**From:** [Alison Kennedy](#)  
**To:** [Hayley Smith](#)  
**Cc:** [Abigail Murphy](#)  
**Subject:** RE: South West Rugby Design Code  
**Date:** 27 May 2025 12:31:01  
**Attachments:** [image001.png](#)  
[image002.png](#)  
[image003.png](#)  
[image004.png](#)  
[image005.png](#)  
[image006.png](#)

**The Town and Country Planning (Local Planning) (England) Regulations 2012  
South West Rugby Design Code Supplementary Planning Document public  
consultation**

Catesby Estates' Consultation Response Table to the South West Rugby Design Code SPD (February 2025)

# Suggested Updates to the Sustainable Transport Link

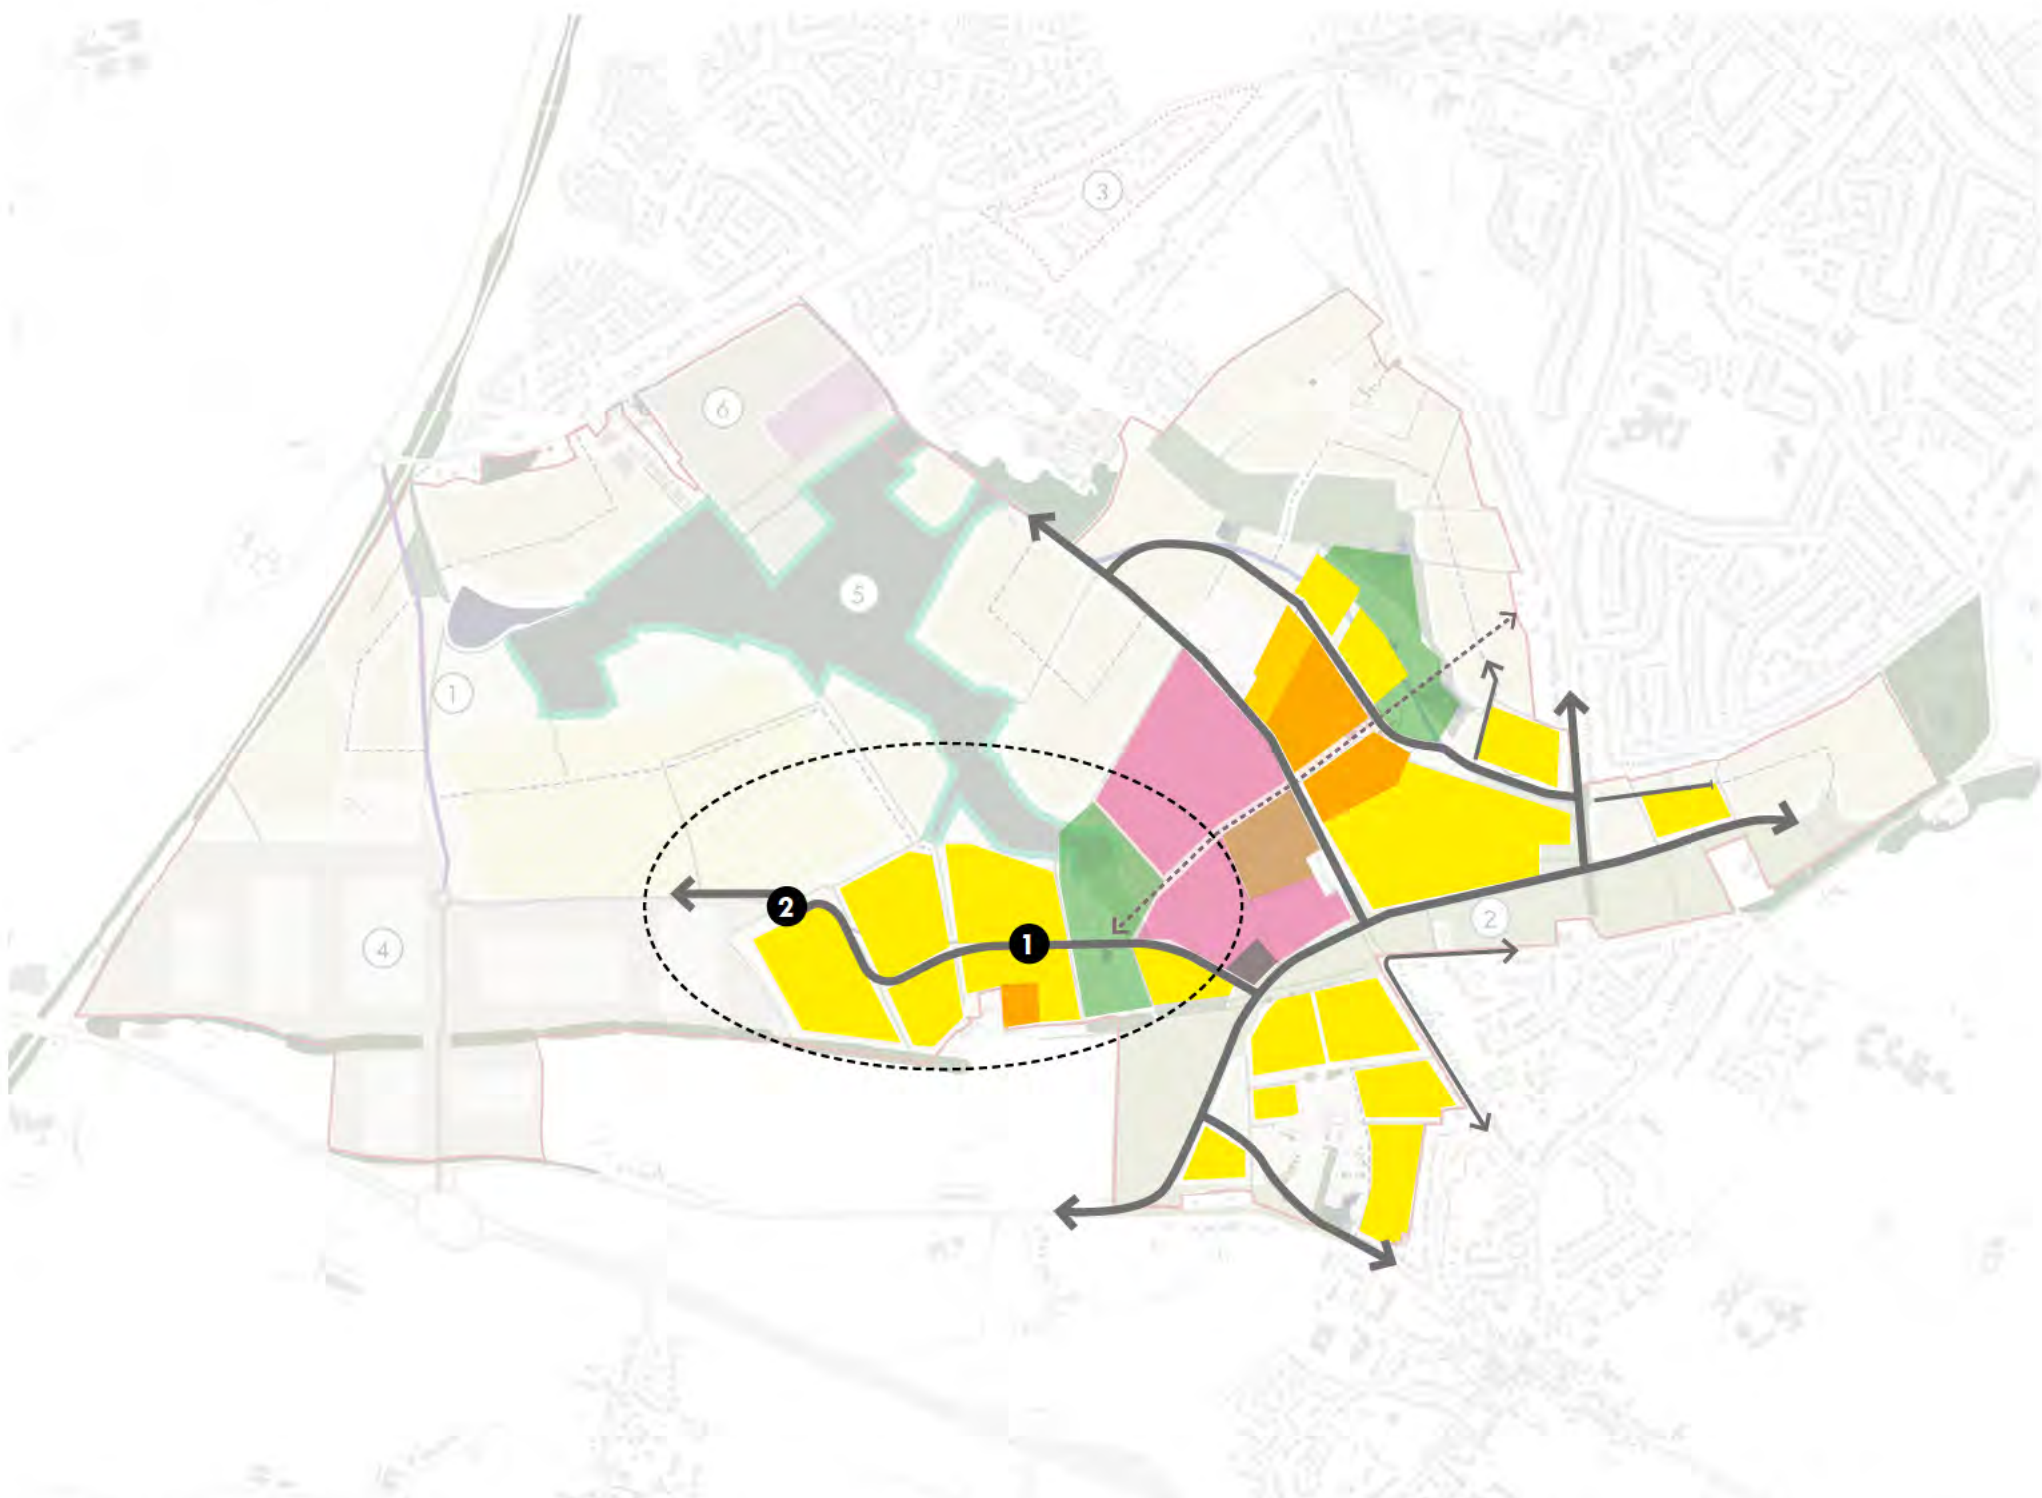
- 1 Suggest the alignment of the Sustainable Transport Link (Windmill Street) is updated to align with Homes England emerging proposals and the access point established by Tritax’s approved application to the west.

Homes England’s proposed alignment includes a couple of bends in the road to support its alignment with Tritax and Homestead Link Road’s approved access points, facilitate the bus gate in accordance with guidance and minimise impact on the existing hedgerows as discussed in our pre application meetings with RBC and WCC in 2024.

# Suggested Updates to the Green Infrastructure Alignment

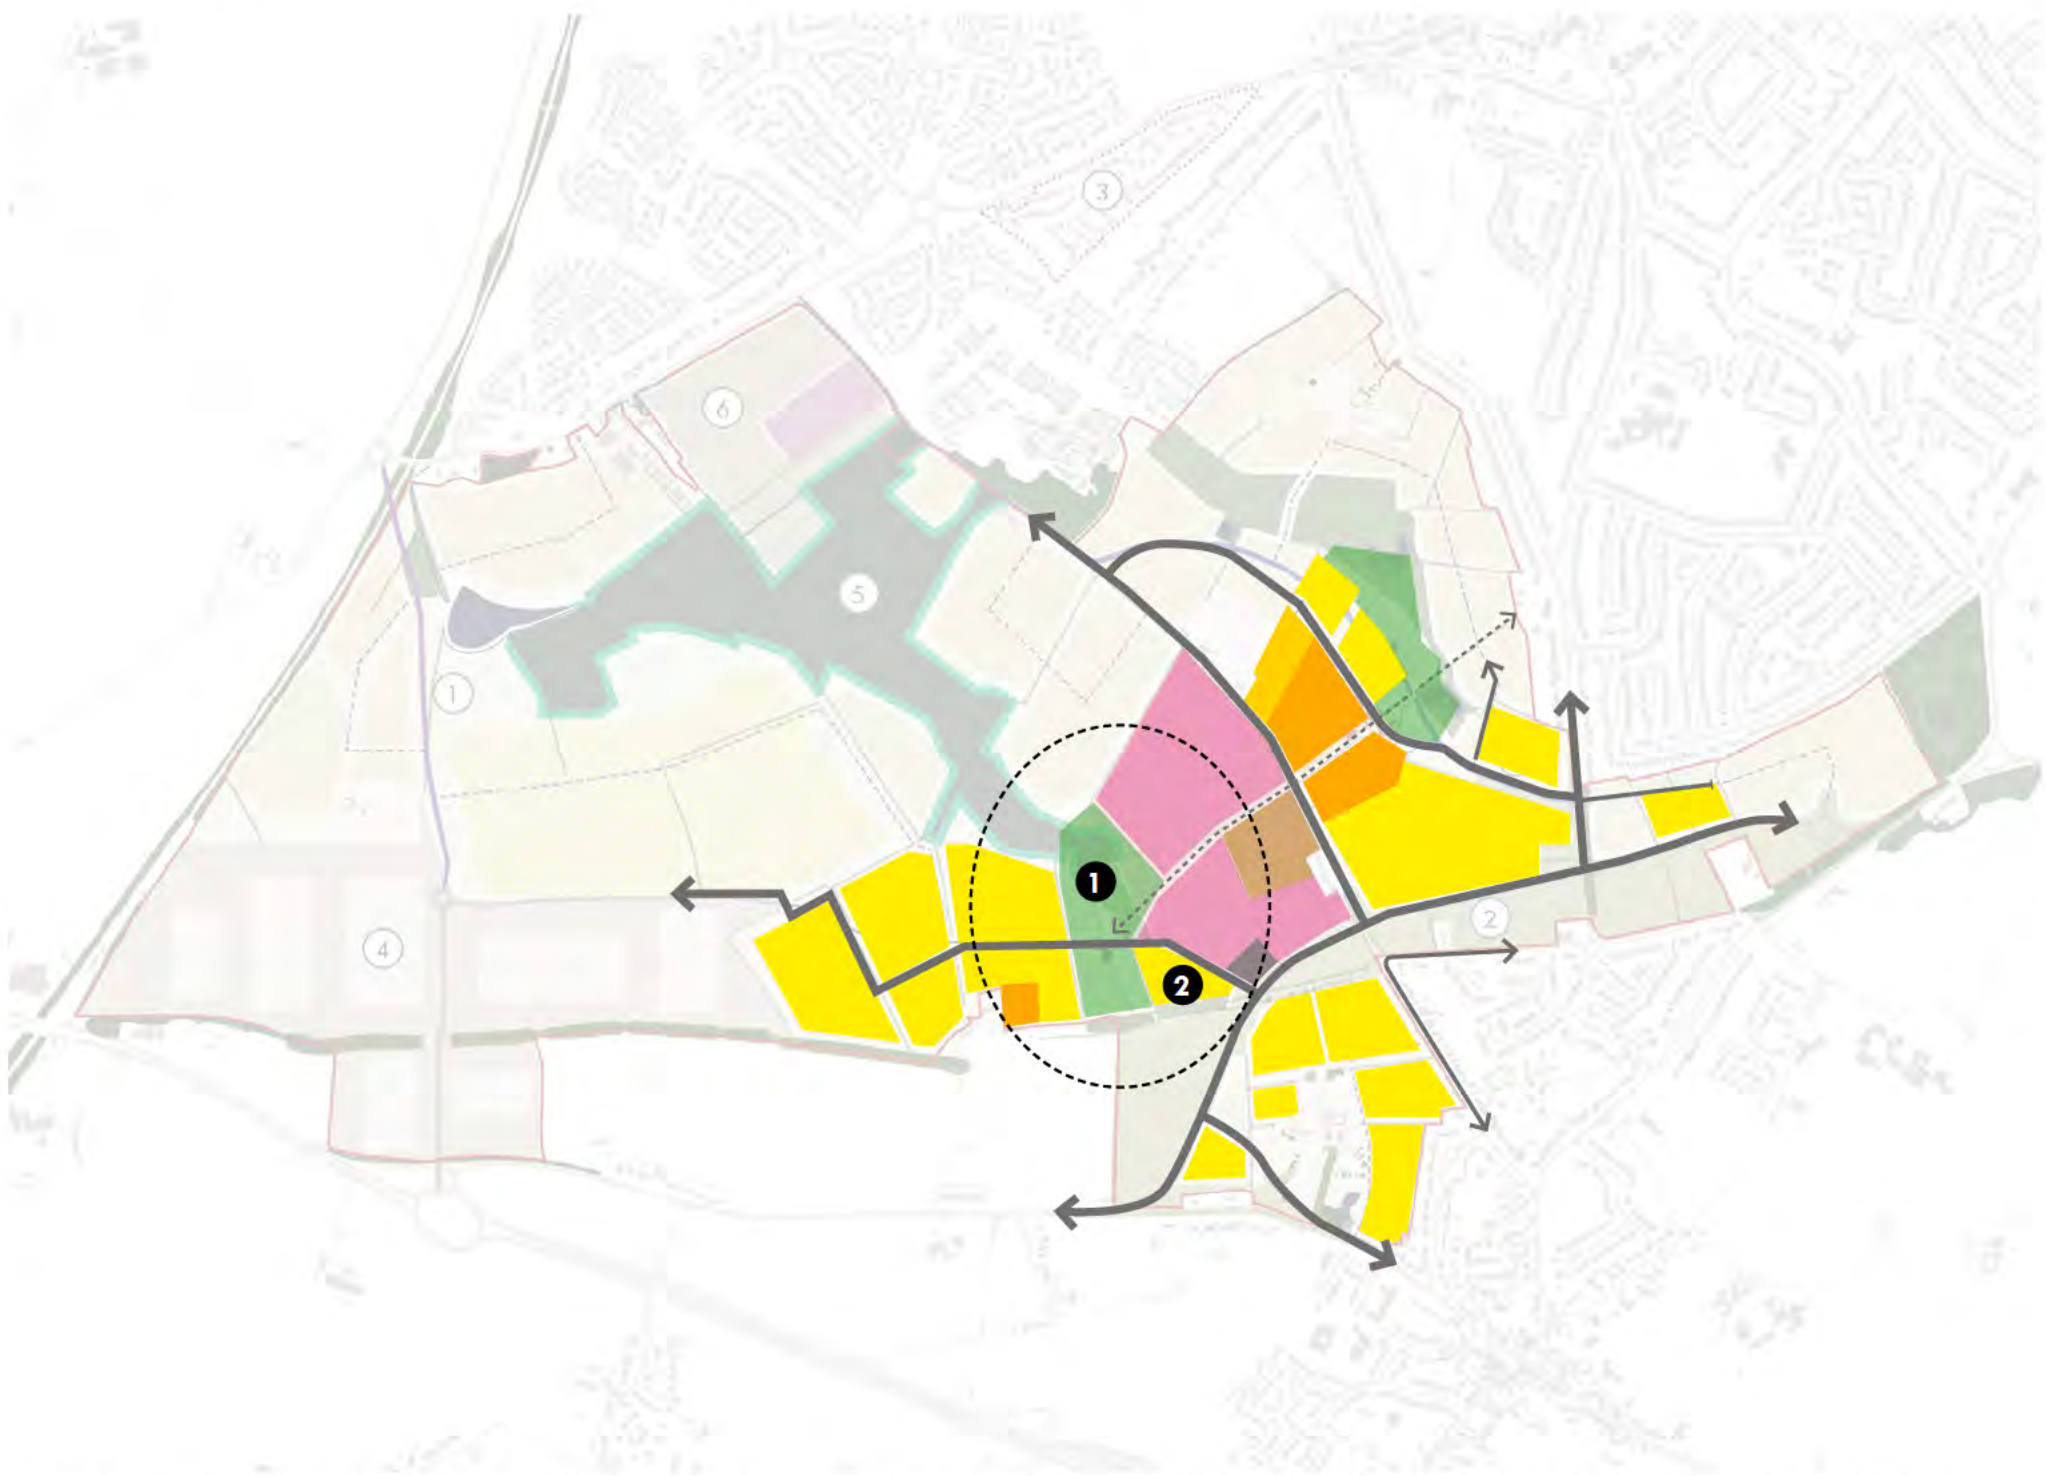
- 1** Suggest the green infrastructure & open space connecting Cawston Spinney and Homestead Link Road should be adjusted and expanded to align with the retention of two existing hedgerows which have ecological importance and support the integration of the development parcel at the entrance from the Homestead Link Road which creates a gateway.
- 2** The triangle of land at the eastern end of the Sustainable Transport Link (Windmill Street) should be identified as a development parcel rather than open space.

# Suggestion for Additional Open Space along Homestead Link Road

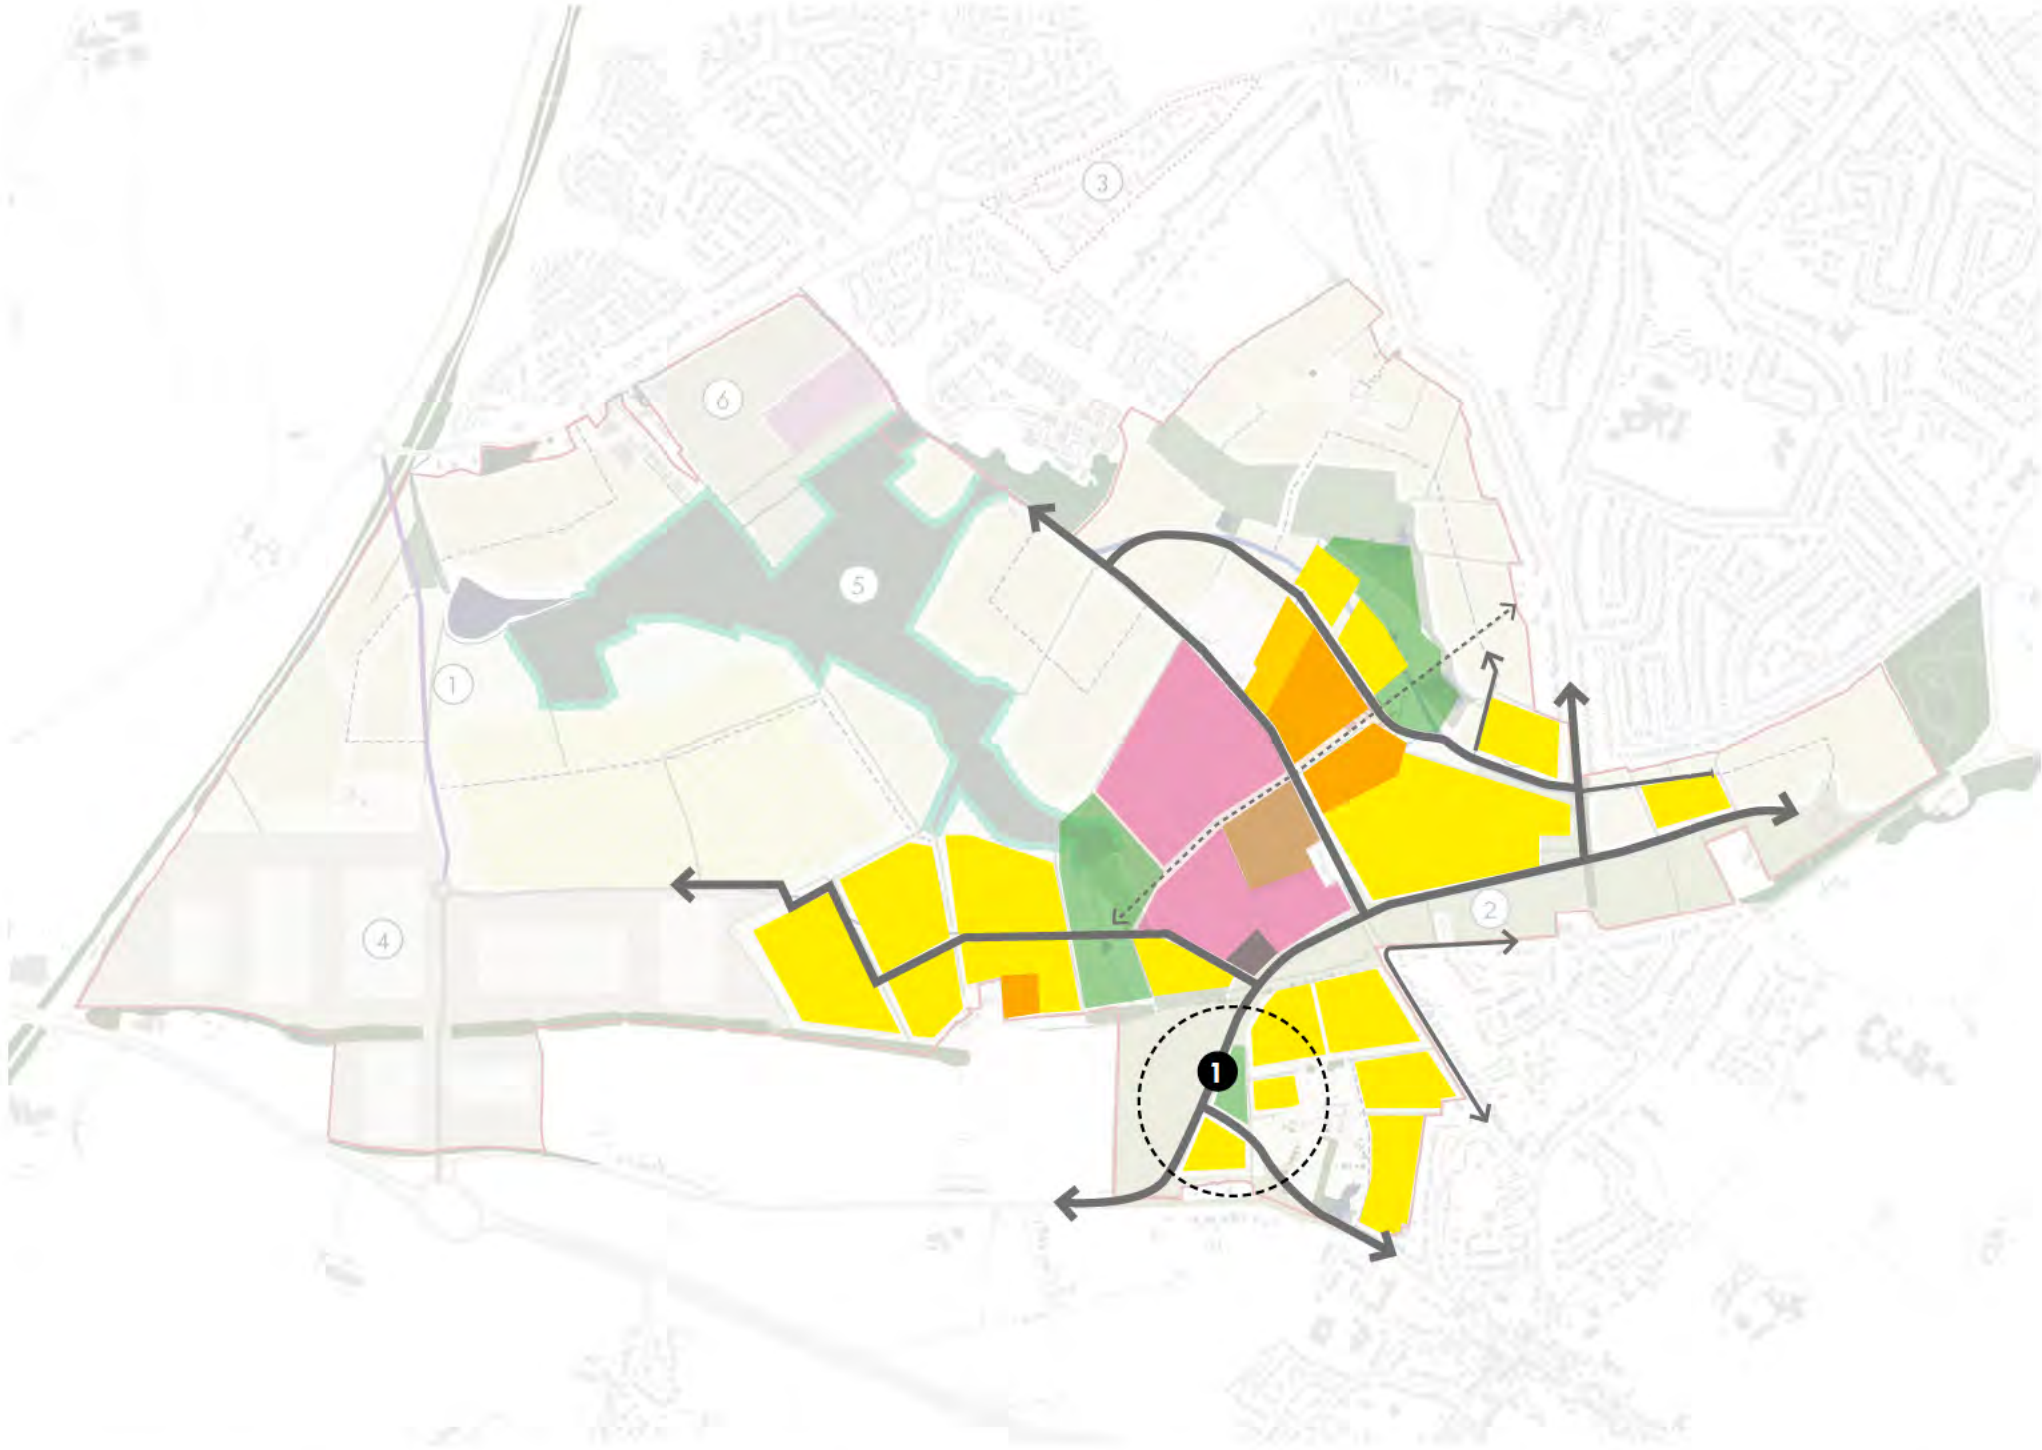
- 1 Suggest that the land highlighted in green on the adjacent markup between the Homestead Link Road and the development to the East should be updated to show it as open space.
